AMENDMENTS TO THE DRAWINGS

REMARKS

Fig. 3

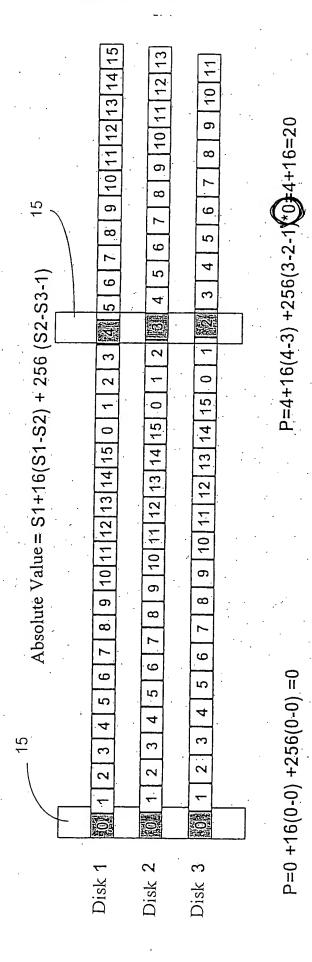
The attached sheet of drawings includes changes to **Fig. 3**. This sheet, which includes **Fig. 3**, replaces the original sheet including **Fig. 3**. In **Fig. 3**, the formula "P = 4+16(4-3) + 256(3-2-1)" P = 4+16 = 20" has been amended to "P = 4+16(4-3) + 256(3-2-1) = 4+16 = 20."

Fig. 3 was objected to because the formula for P incorporated therein "256(3-2-1)*0" appears incorrect. The drawings were objected to under 37 C.F.R. §1.83(a) as the drawings fails to show "the bearing arrangement" in claim 14.

In the Replacement Sheet for **Fig. 3**, the formula has been amended to have "256(3-2-1)." Claim 14 has been canceled without prejudice or disclaimer, thereby this objection moot.
